REFRIGERATORS REF 18-00 SIDE-BY-SIDE 20/21/22/24/25/27/28/30 CU. FT. MODELS DEFROST HEATER ICING ISSUES

SIDE-BY-SIDE DEFROST HEATER ICING ISSUES

For Side-By-Side 24/28/30 Cu. Ft. Models:

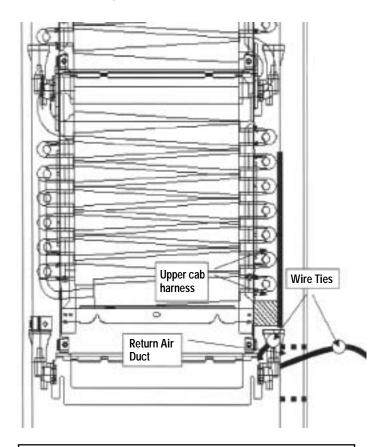
Starting in June of 1999, Side-By-Side refrigerators were produced with only one defrost heater system in place of the previous two defrost heater system. The new system passed all necessary testing. However, evaporator icing issues have been seen in the field. At this stage, when such a situation is found, the best solution is to replace the single element defrost heater with the previous dual element defrost heater (WR51X0443 or WR51X0442). See the instructions below for how to retrofit the models.

- 1. Disconnect and remove the single element defrost heater and harness assembly.
- 2. Install the dual element heater.

NOTE: THE HARNESS SHOULD NOT COME IN
 CONTACT WITH ANY SHARP EDGES OF THE
 EVAPORATOR OR SPINE FINS. ANY PORTIONS OF
 THE HARNESS WHICH COMES IN CONTACT WITH
 SHARP EDGES OF THE EVAPORATOR BRACKET OR
 SPINE FINS MUST HAVE ALUMINUM TAPE
 WRAPPED AROUND THE HARNESS TO PREVENT
 WEAR ON THE WIRE. EXCESS HARNESS SHOULD BE
 BOUND TOGETHER TO AVOID ANY POSSIBILITY OF
 INTERFERENCE WITH THE EVAPORATOR FAN.
